Kevin Bilash  
US Environmental Protection Agency Region III  
1600 John F. Kennedy Boulevard  
Philadelphia, PA 19103

February 3, 2023  
File No. 4862.10

Re: Revised Responses to USEPA's October 13, 2022 and December 15, 2022 Comments  
Concerning the September 2022 IM Monthly Progress Report for AOI 7 in MHT

Exhibit 5. Arsenic and Iron pe-pH Diagram

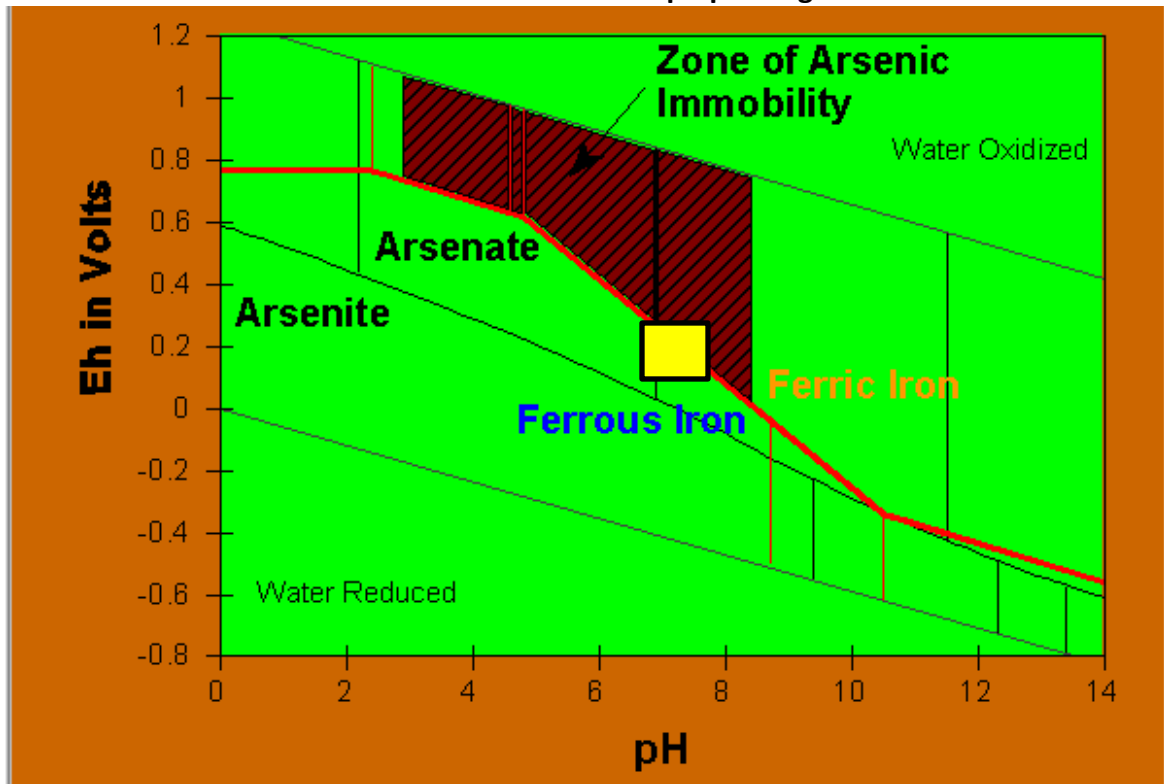
**Comment 6:** Discussion 3. Please incorporate site specific surface water pH/eh measurements plotted on the Arsenic and Iron pe-pH diagram, similar to Exhibit 1, into the evaluation.

**Response to Comment 6:** Exhibit 5 in Attachment D shows the arsenic and iron pe-pH diagram. The yellow box placed on the graph are the site-specific surface water pe/pH measurements that were collected during the March 2021 porewater sampling event. The site-specific pe/pH measurements fall mostly within the dissolved phase of the arsenic-iron pe-pH diagram, demonstrating that arsenic at the surface water interface will not precipitate and accumulate in sediment. However, using the arsenic solubility diagram presented in Exhibit 6 of Attachment E based on the Geochemist's Workbench model is more representative of arsenic solubility in surface water conditions at the site than using the arsenic and iron pe-pH diagram in Exhibit 5 because the Geochemist's Workbench factors in multiple anions/cations that would affect solubility of arsenic rather than iron only. The pe-pH diagram in Exhibit 5 only represents conditions for arsenic and iron only and is not representative of the full sediment and surface water environment like the Geochemist's Workbench solubility diagram. See Response to Comment 5 above regarding surface water cation/anion collection to confirm the Geochemist's Workbench calculations.

### **Figures 16 - 18**

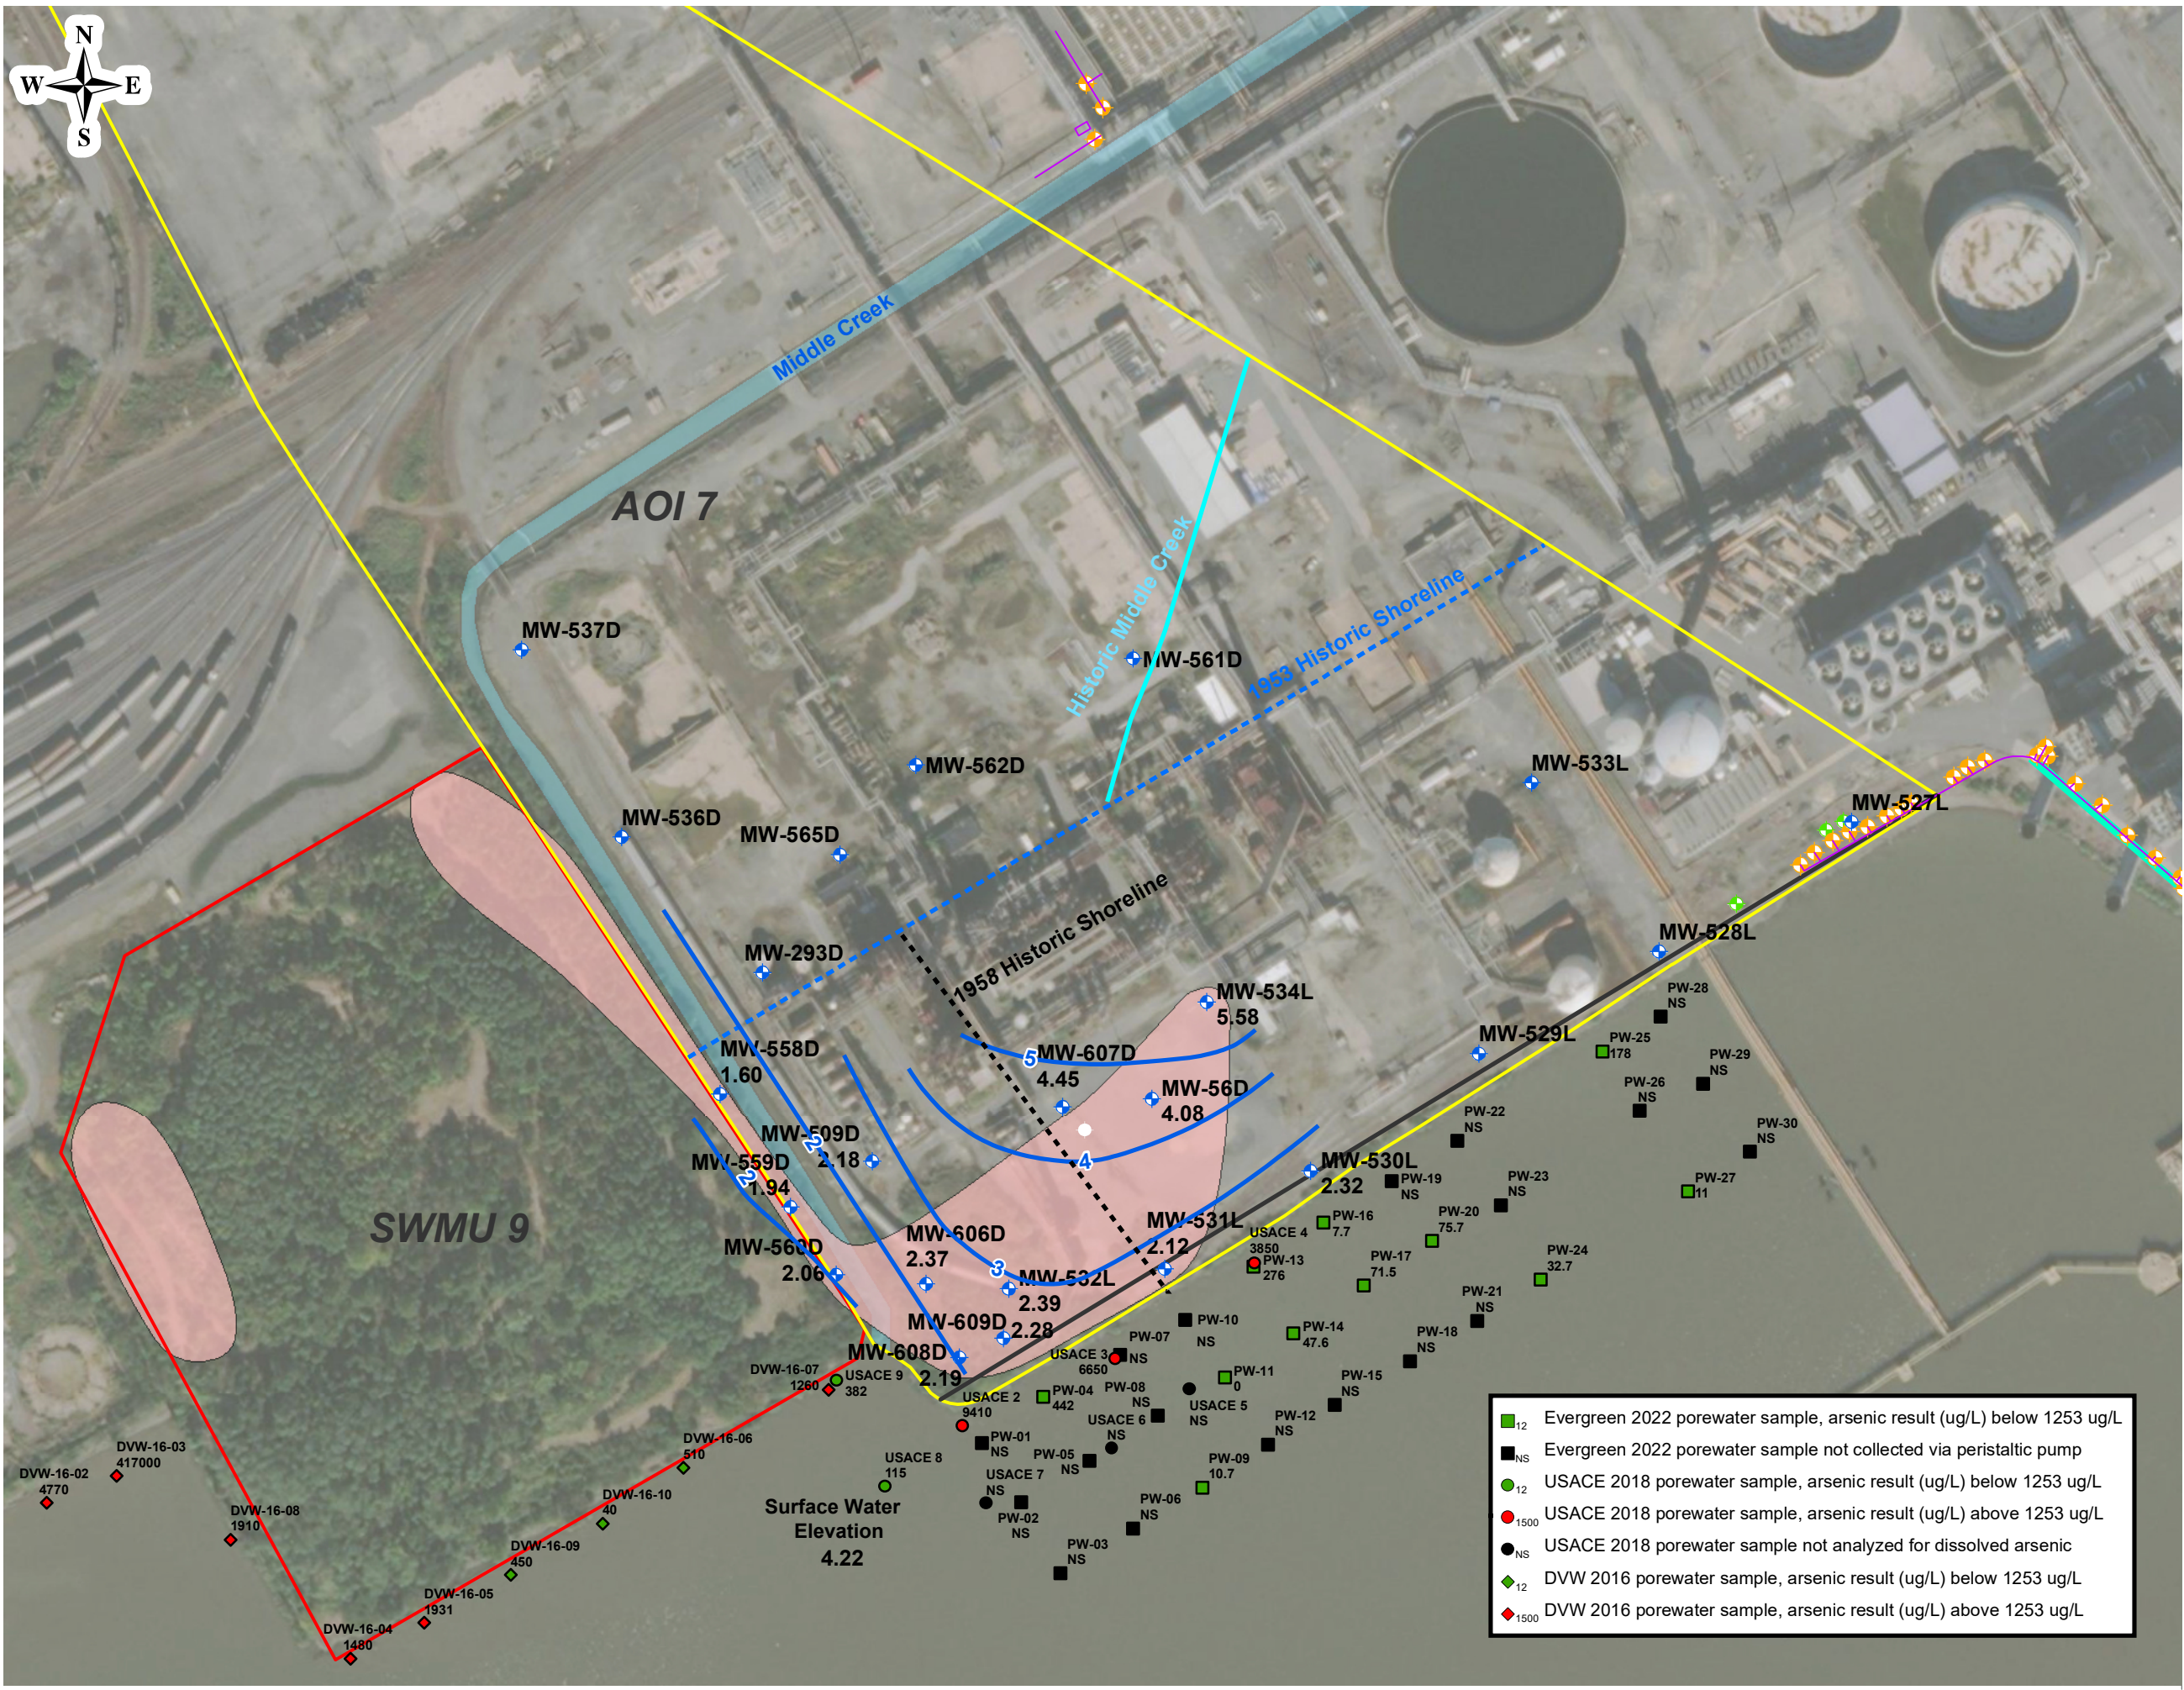
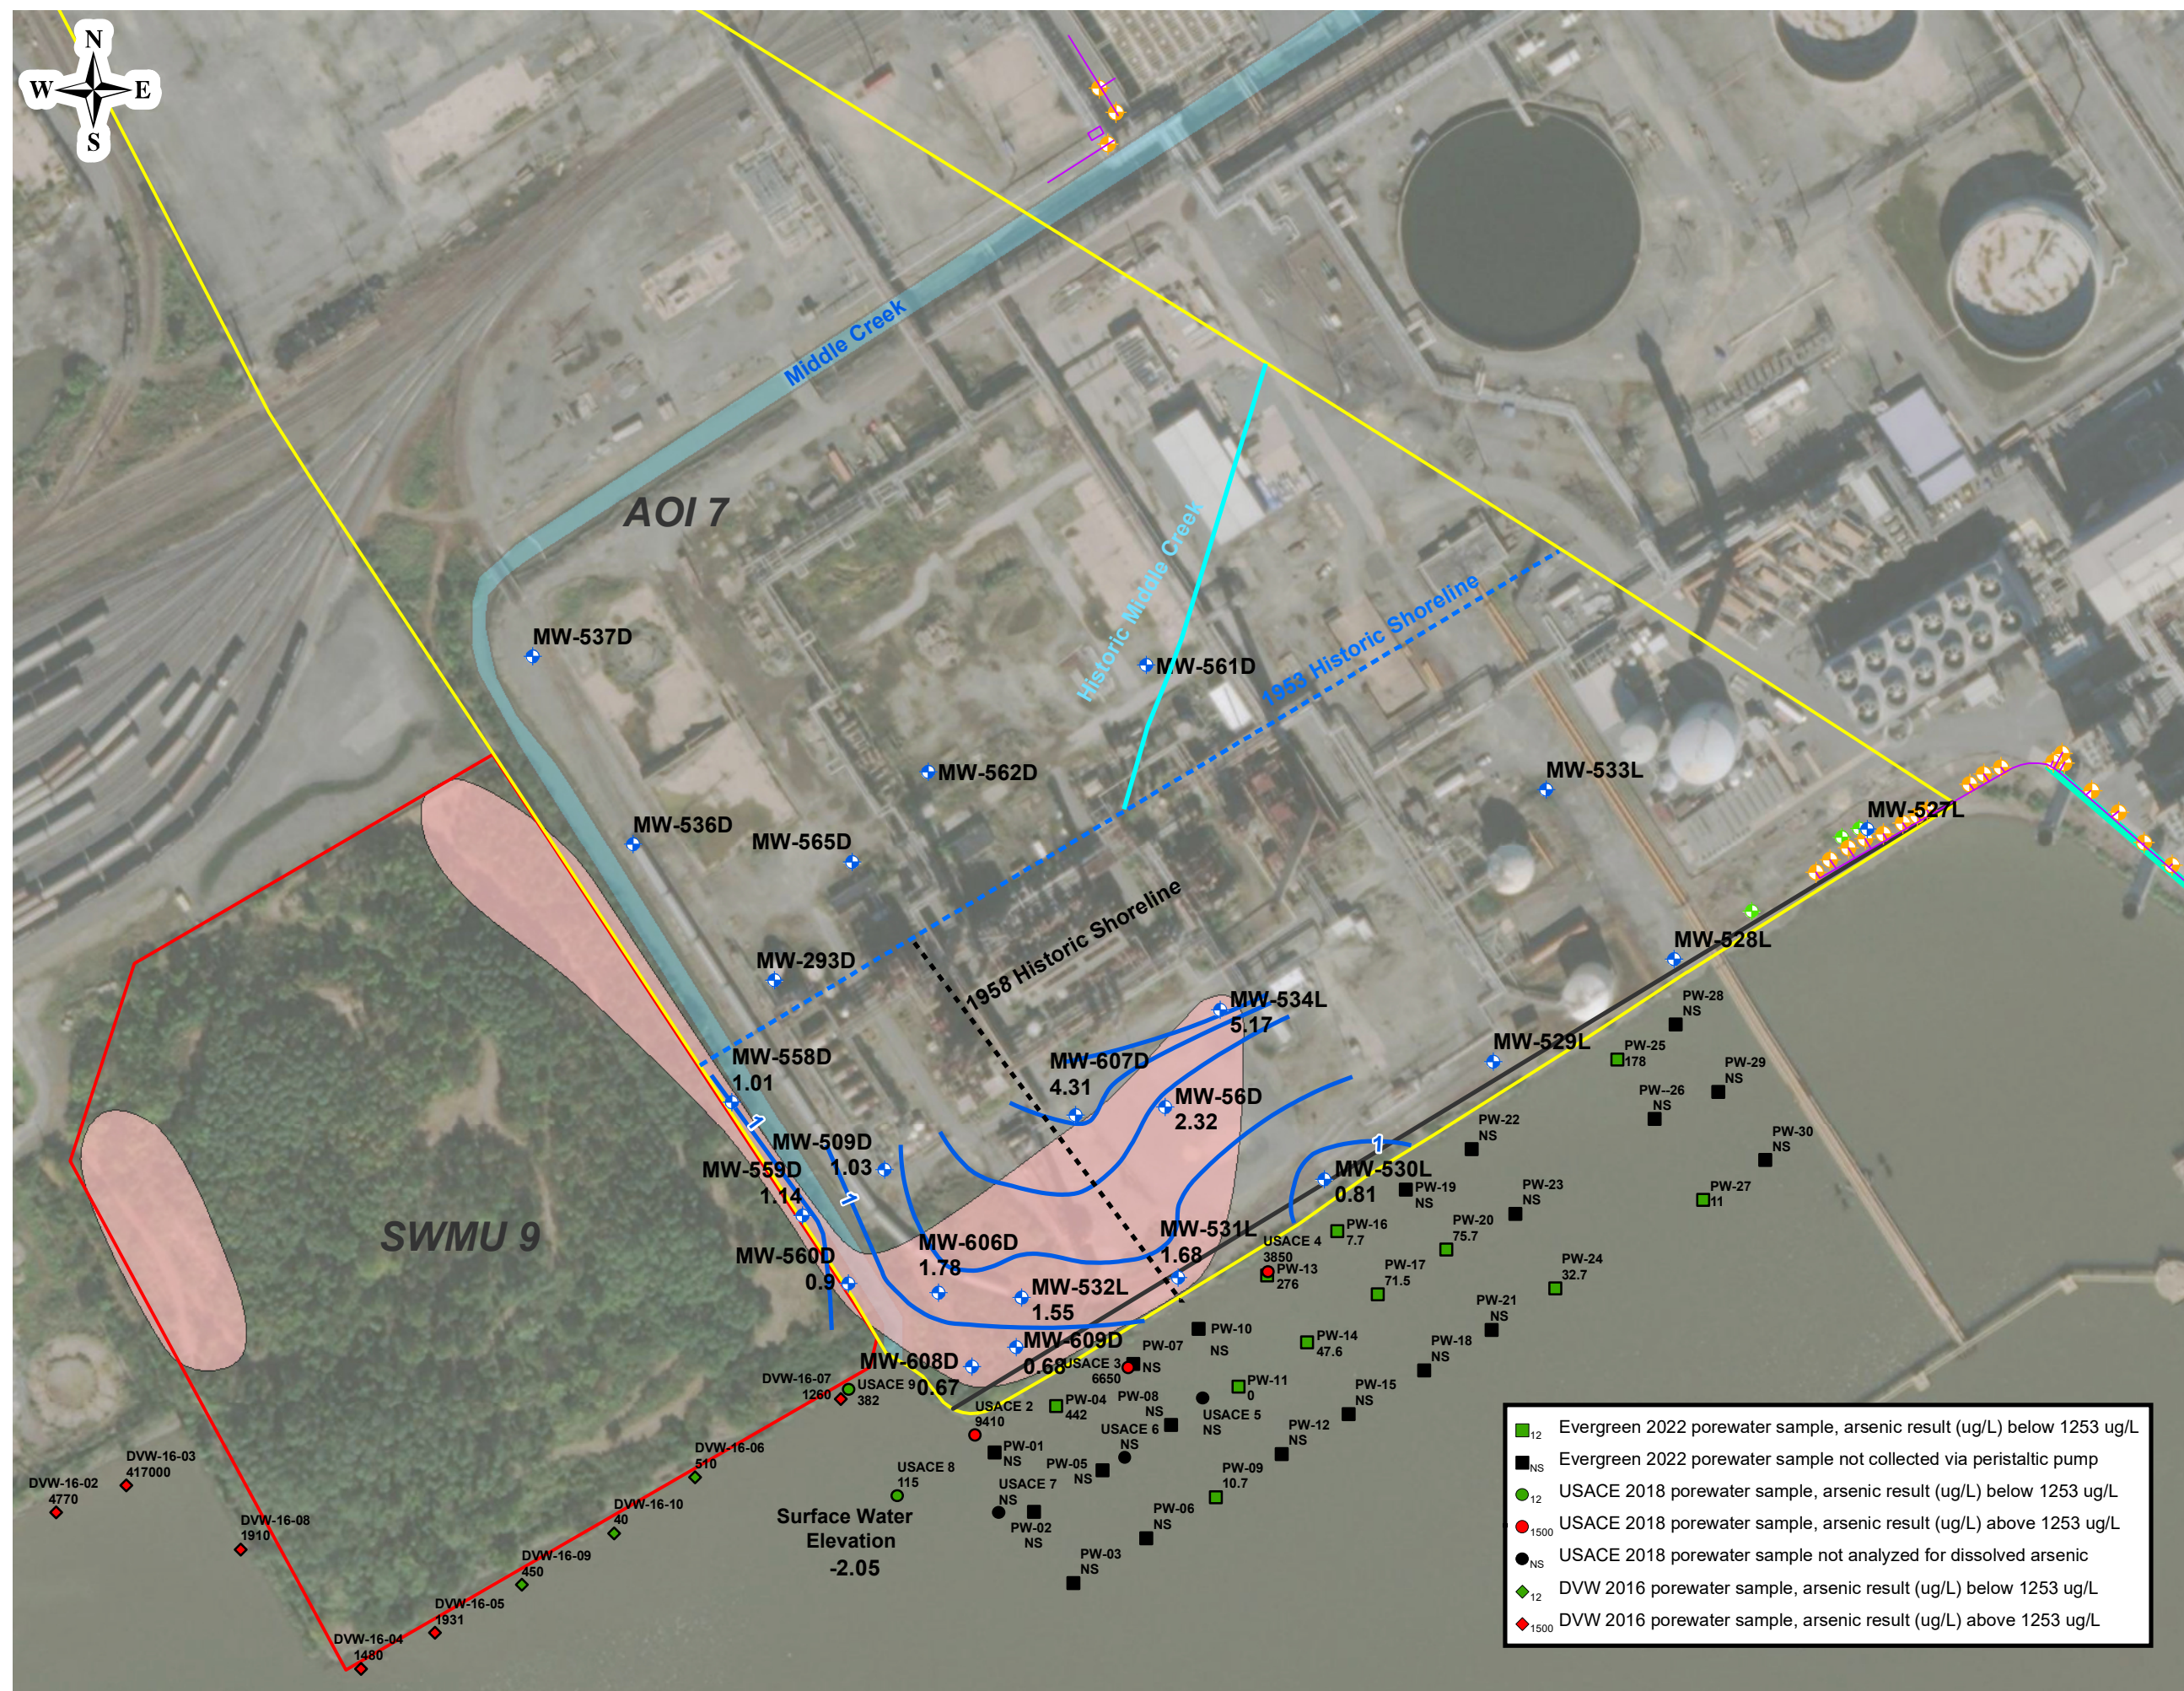
**Comment 6:** *Figures 16-18: Revise sample identifiers from ND to NS.*

**Response to Comment 6:** Figures 16-18 have been revised (see Attachment F) to reflect any porewater locations that were not sampled to be designated as “NS” instead of “ND”.
